UNITED STATES PATENT AND TRADEMARK OFFICE

APPLICATION NO.	FILING DATE	FIRST NAMED INVENTOR	ATTORNEY DOCKET NO.	CONFIRMATION NO.
09/941,934	08/30/2001	Joe Cargnelli	9351-072	6332

Office Action Summary

DETAILED ACTION

FIGURE 4. THE MODIFIED FIGURE CORRESPONDS TO FIGURE 1

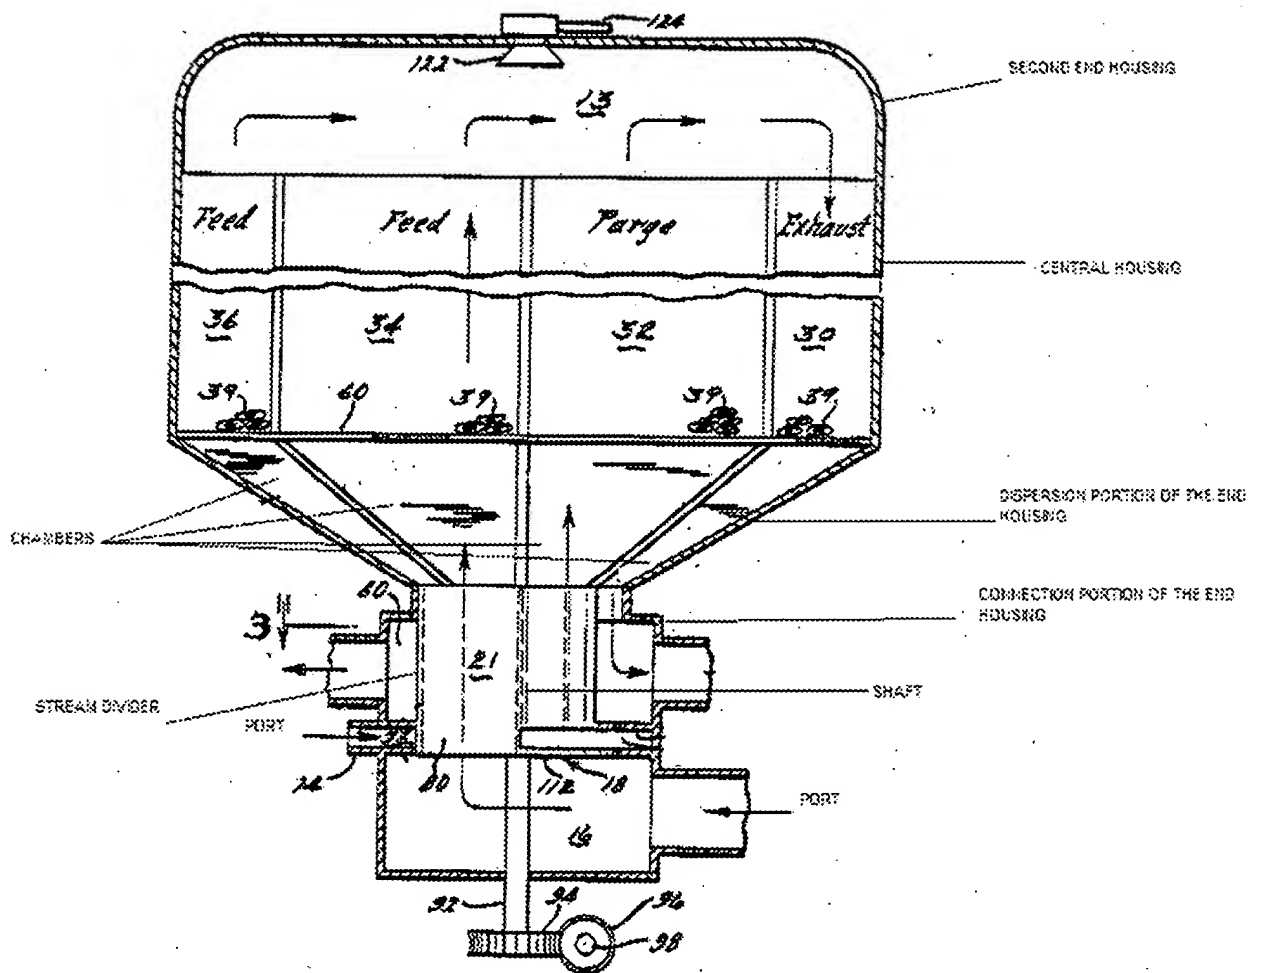
Claims 1-3,5,9,11-20,27,29,33,35-42 and 48 rejected under 35 U.S.C. 102(b) as being anticipated by Thomason (US 5,016,547). Thomason discloses (figures 1-4, A and column 3, lines 37-42) a regenerative energy exchange assembly comprising an exchange media (39) disposed in many media cavities (30-36) having a casing; a first chamber and a second chambers

having a first, a second fluid channels adjacent the exchange media (39) to pass a first fluid stream and a second fluid stream through the exchange media respectively; the first and second chambers separated by dividers (40,44,50,52); at least one fluid stream diverter (80) being rotatable relative to the chambers and providing separate flow communications to the chambers through the respective fluid channels; the fluid stream diverter having a radial extent that is less than the functional radial extent of the exchange media, wherein, at any given diverter orientation, the separate flow communications are not in fluid communication with the same chamber; an end housing connected to one end of the exchange media (1) and wherein the fluid channels are provided in the end housing; the end housing has interior walls defining an inner enclosure, and the fluid stream diverter (80) is provided in the inner enclosure; the fluid stream diverter is rotatably mounted within the inner enclosure to provide the diverter within the adjustable orientation; a shaft extends rotatably through the exchange media, and the housing wherein the fluid stream diverter (80) is fixed to the shaft; the housing comprises a connection portion and a dispersion portion which are in fluid communication with each other; the dispersion portion has an open end that is in fluid communication with the exchange media; the connection portion has ports in flow communication with the respect fluid channel and has a radial extent that is less than the radial extent of the dispersion portion; the dispersion portion comprises the first and the second chambers. Thomason further discloses (figure 1) the exchange media is housed in a plurality of media cavities (30,32,34,36) that are separated from one another in cross section and extent in parallel along the exchange media; the plurality of media cavities are positioned in correspondence to the chambers of the dispersion portion; the plurality of cavities are disposed within the casing. Thomason further discloses (figure 4) the

connection portion has an open end and a closing means (110,70), which partially closes the open end. Regarding claim 48, an annular plate (70) is considered to be a sealing means provided between the connection portion (20) of the housing and the fluid stream divider (80) so that no fluid is cross-flow between any channels. Since the channels, ports and chambers are located beyond the joining location between the end housing and the central housing, the attachments between the end housing and the central housing are independent from the flow of fluids between ports, channels and chambers.
